Best Available Technique Assessment

Colt Hayes L4 Data Centre

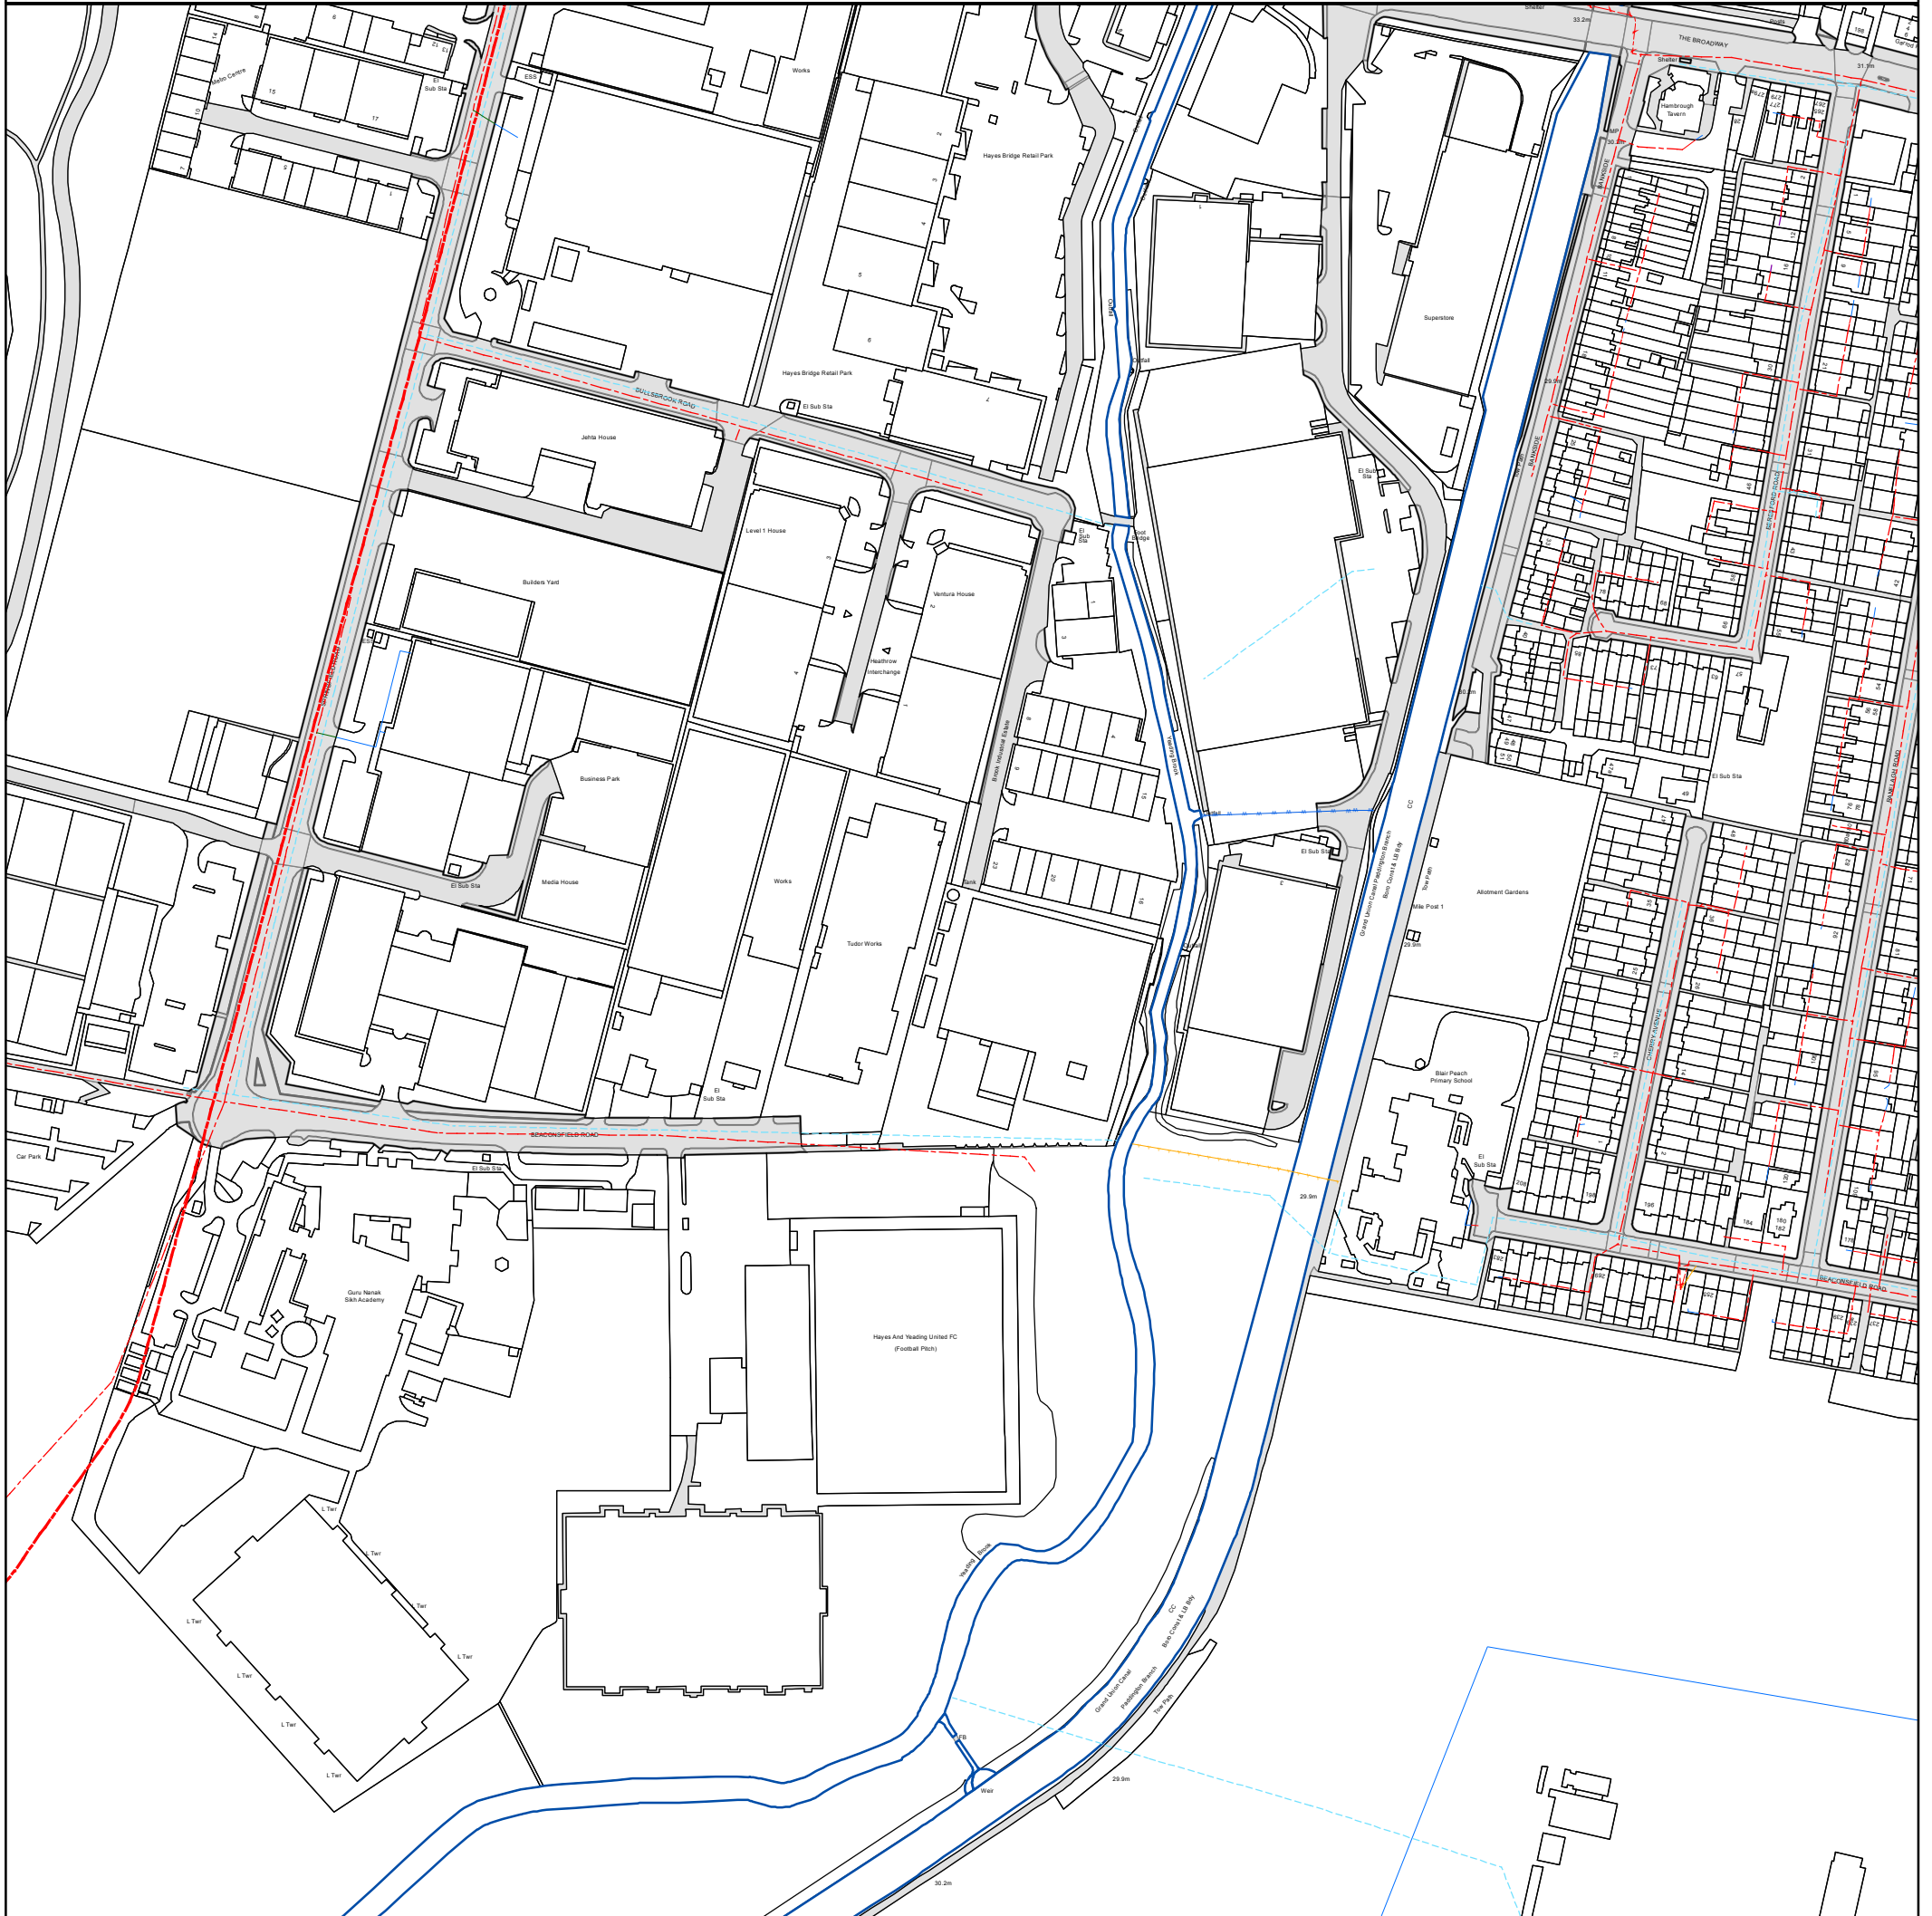
Comments:
